REPORT OF
RETENTION POND STUDY

FANSTEEL, INC.

FANSTEEL RESPONSE TO:
REQUEST FOR ADDITIONAL INFORMATION

WASTE RETENTION POND

SUBSURFACE
PROFILE

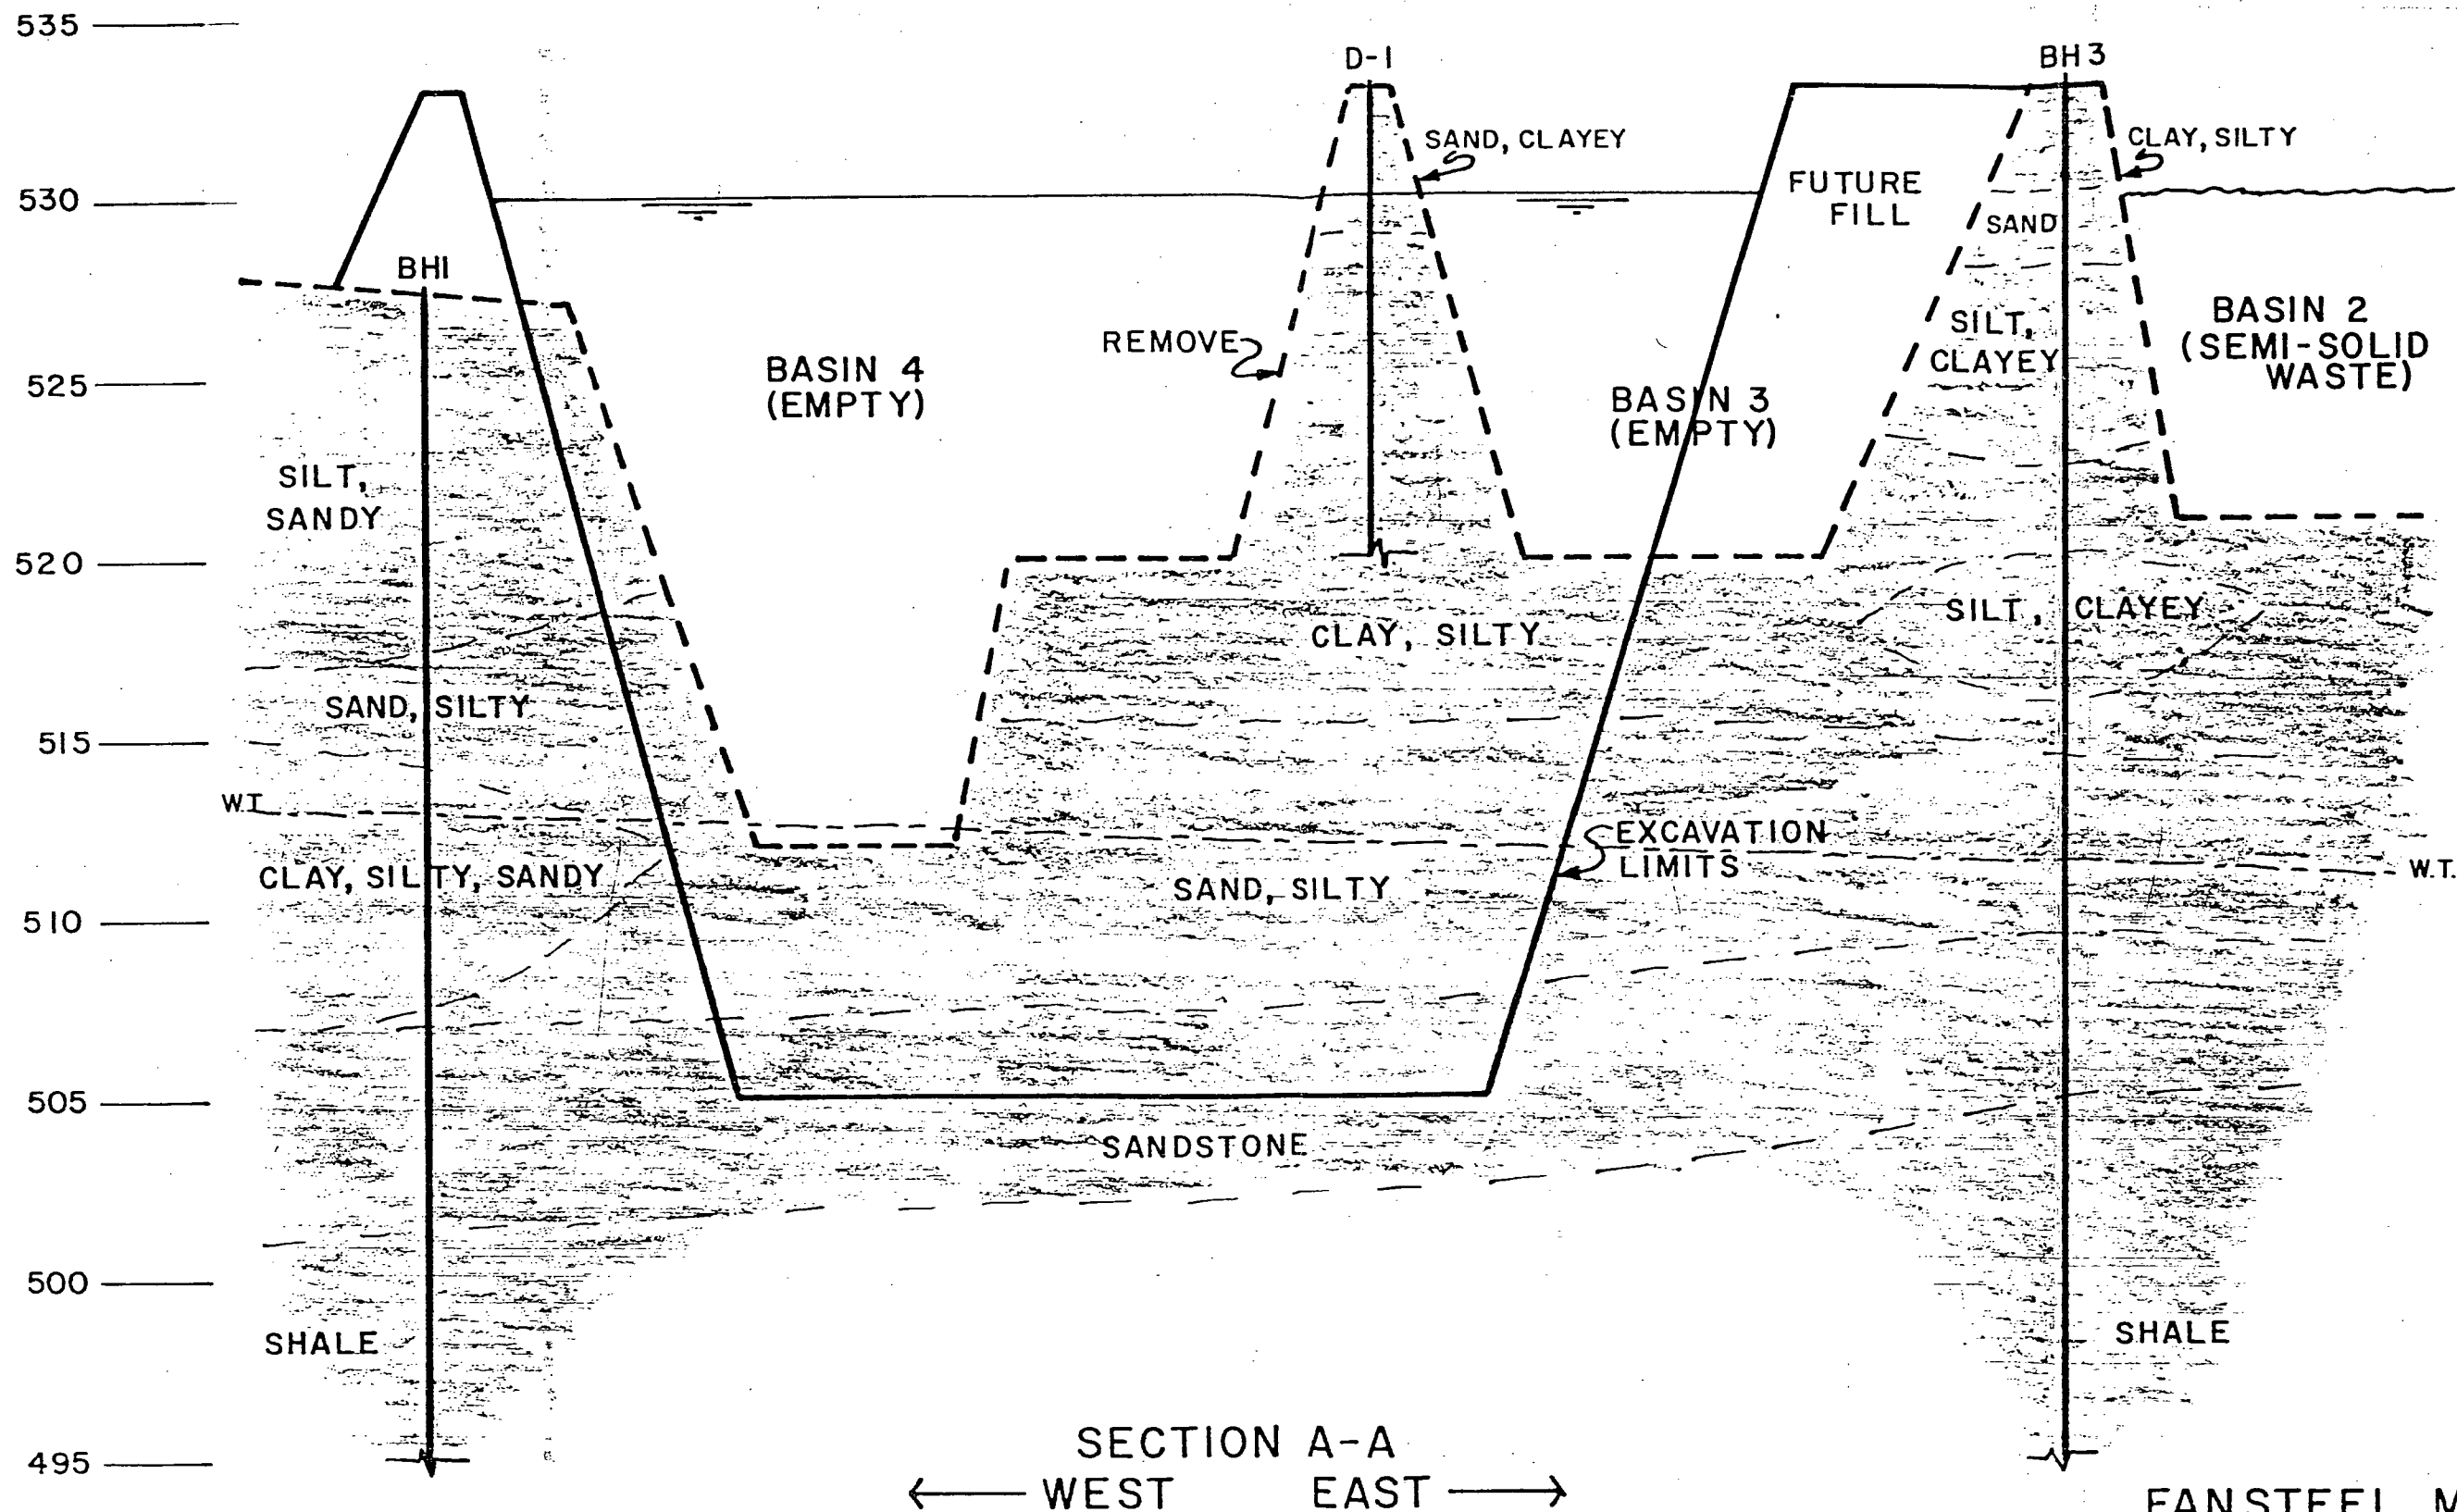
ITEM 12 Provide Information Regarding Your Proposed
Monitoring Program for Ground Water and Surface
Water.

As stated in 362.25, two observation wells are to be located, one on the North Dike, and a second on the South Dike of the proposed pond to monitor any seepage.

In addition, the exterior French drain system will discharge to 5' in diameter observation sump prior to overflowing to the river. The water at the observation sump will be routinely maintained.
